Docket Item #5  
BAR CASE #2010-0297

**ISSUE:** Alterations (Window Reconfiguration and Replacement)  
**APPLICANT:** W.H.I.T. Limited Partnership by On the Mark Management  
**LOCATION:** Southside Cafe at 815 South Washington Street  
**ZONE:** CRMU/L Commercial

Figure 1: Existing and Proposed Drawings

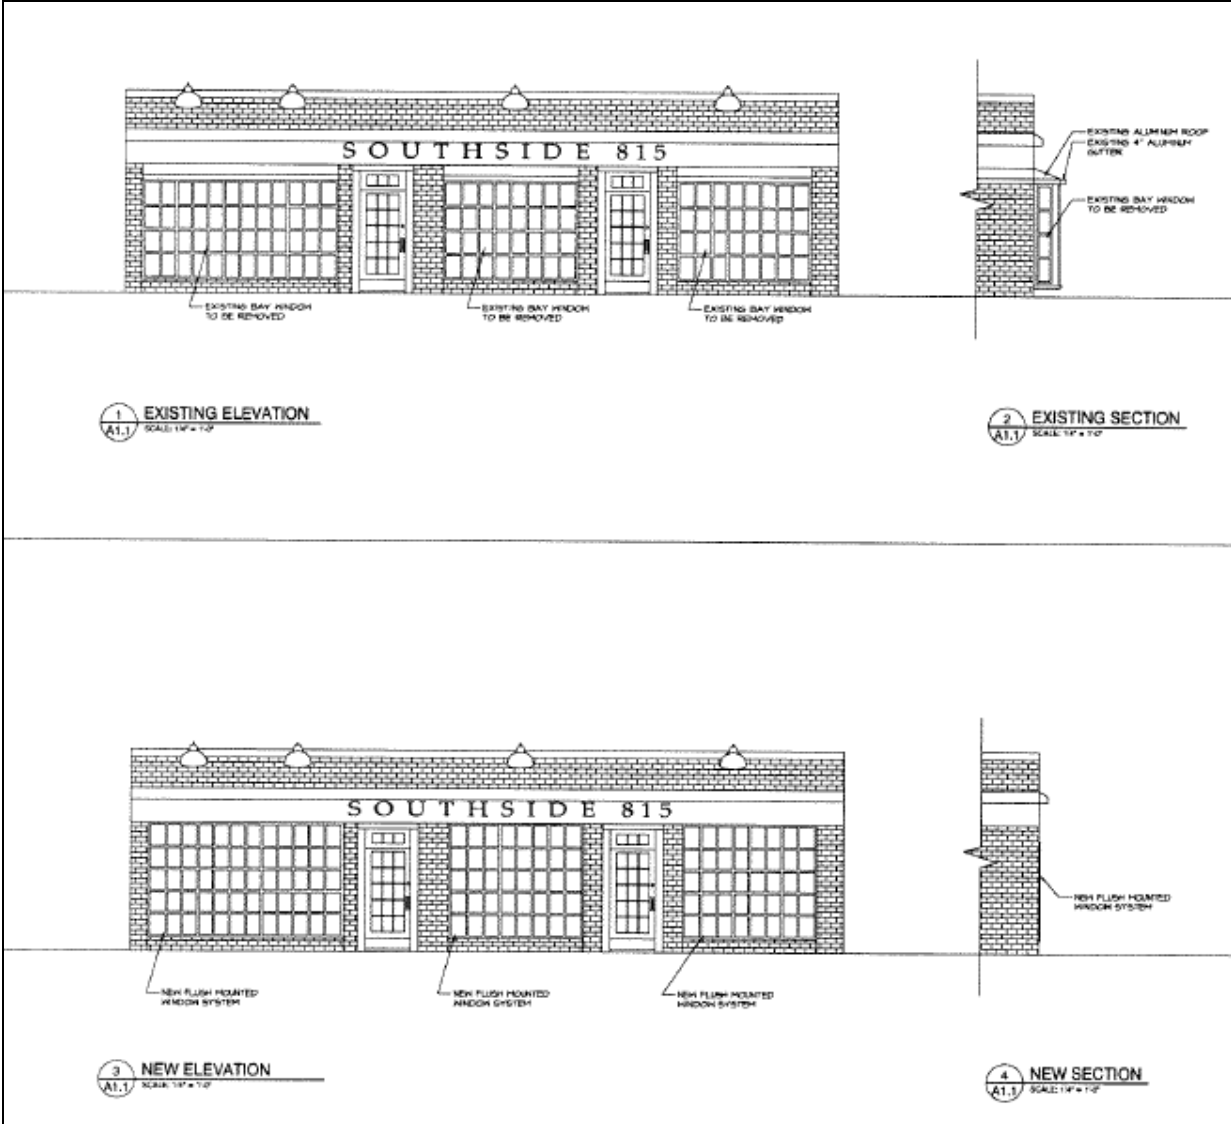
The applicant is proposing to replace three, multi-light, bay windows on the storefront. The existing windows are single-glazed, fixed, multi-light windows. The applicant is requesting approval of painted, double-glazed, full-frame replacement wood windows installed flush mounted to the existing storefront. The proposed windows will be multi-light, true-divided light windows constructed in an identical multi-light pattern to the windows they are replacing. The 2-3/16" muntins will have a beaded profile. The new flush mounted, windows will be installed in the original openings.

Therefore, given the age of the shopping center, the fact that the existing light pattern and size of the openings will be maintained and the bay window storefront is not original to the period of construction, Staff does not object to the removal of the bay window storefronts and replacing them with flush mounted double-glazed wood windows with true divided lights. However, Staff does note that the application specifies a beaded profile for the muntins. This profile does not meet the adopted *Alexandria Window Performance Specifications*, which requires the muntins to be detailed with a putty glaze profile. Yet, since the existing windows contain a beaded muntin

**STAFF RECOMMENDATION:** Staff recommends approval of the Certificate of Appropriateness application, as submitted.

Figure 2: Proposal

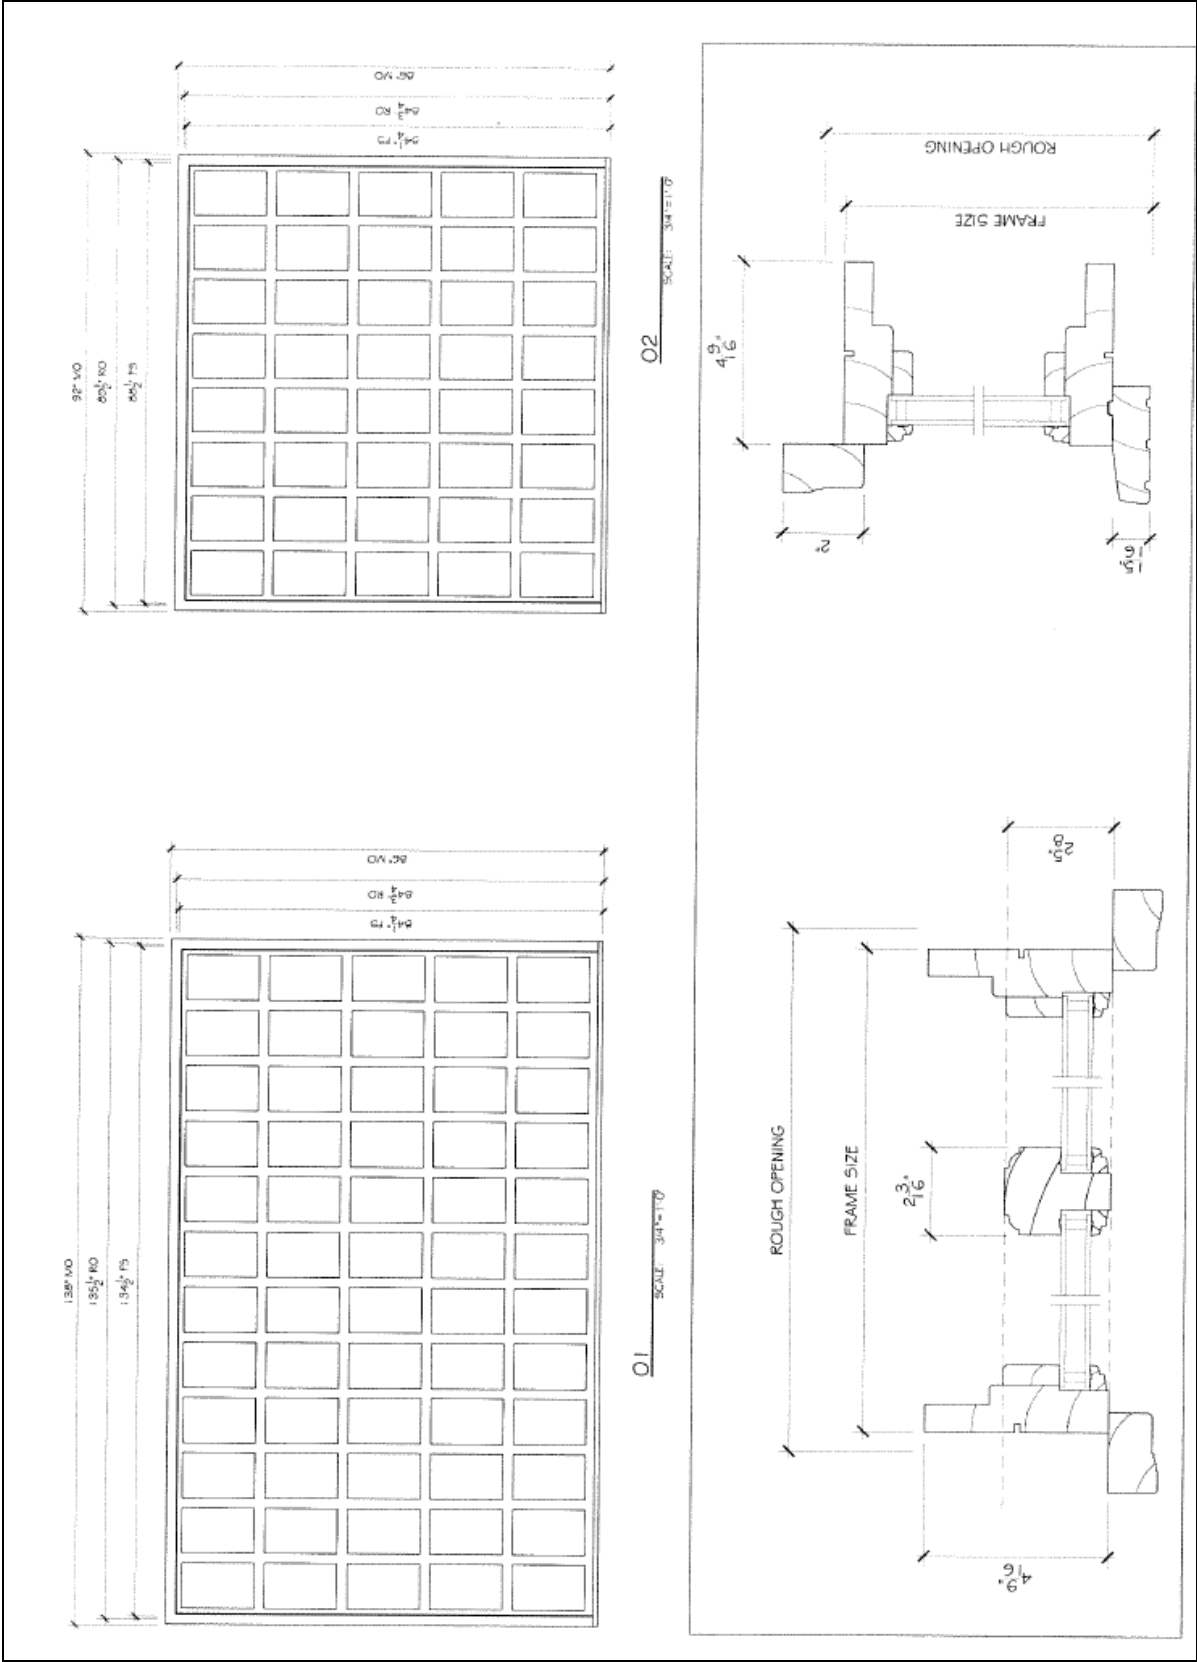
profile (see photo on page 8), staff believes that the window profile, as proposed, is appropriate for this application.
